Office Action Summary

10/803,337

LI ET AL.

DETAILED ACTION

Figure 1 – Figure 4 of US 2005/0199087

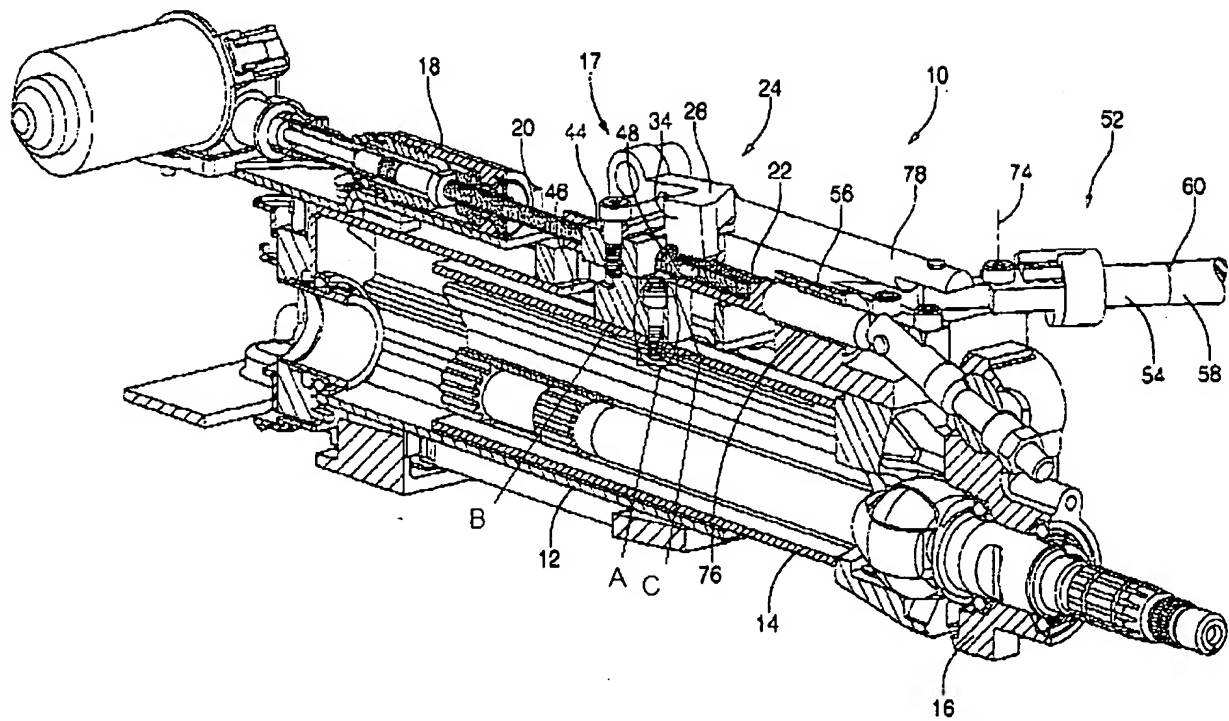
- First end (right side of (20) shown connected to (22)) pivotally connected to tilt housing (see fig 4, (20) is connected to tilt housing via (22))
- Second end (see fig. 4, left side of 20 is shown connected to lower steering column jacket via (18)) slidably connected to lower steering column jacket.

- Wherein said linking member moves linearly in response to telescoping and tilting movement (see fig 4).
- Said single locking device includes a wedge member (see fig 1 below, (A)) rotatably associated with lower steering column jacket and moveable between a locked position and unlocked position (wedge member can be tightened and locked or loosened and unlocked, wedge member is rotatably associated with lower steering column jacket in that it is rotatable relative to lower steering column jacket)

- Lower steering column jacket defines an aperture (46) with an enlarged portion (enlarged portion is considered to be opening inside lower steering column jacket) wherein said wedge member (A) extends through said enlarged portion.

- Lower steering column jacket including a guide (18) having an aperture (see fig 4, right side of 18 shows an aperture which (20) passes through) for receiving second end.

- Single locking device includes first engaging element (see fig 1 below, (B)) fixedly associated with said upper steering column jacket and adjacent to said wedging element.

- Single locking device includes second engaging element (34) movably associated with lower steering column jacket and adjacent to linking member (see fig 4).

- Wherein said lower steering column jacket includes a guide (18) having a first aperture (see fig 4, right side of 18 shows an aperture which (20) passes through) and a second aperture (see fig 4, left side of 18 shows an aperture which (20) passes through)

- Said second aperture (see fig 4, left side of 18 shows an aperture which (20) passes through) including an enlarged portion (see fig 4, enlarged portion is defined by threaded portion of aperture) and single locking device including an engaging element (see fig 4, threaded bushing shown inside of (18) is considered to be an engaging element) in enlarged portion

- Said wedge member defines a pair of first surfaces (see figure below, (C) are top and bottom surfaces of wedge member) extending substantially parallel to one another and spaced from one another a first distance wherein said first distance is greater than a second distance defined between said linking member and said upper steering column jacket (see fig 4, length of wedge member appears greater than distance from linking member to upper steering column jacket)
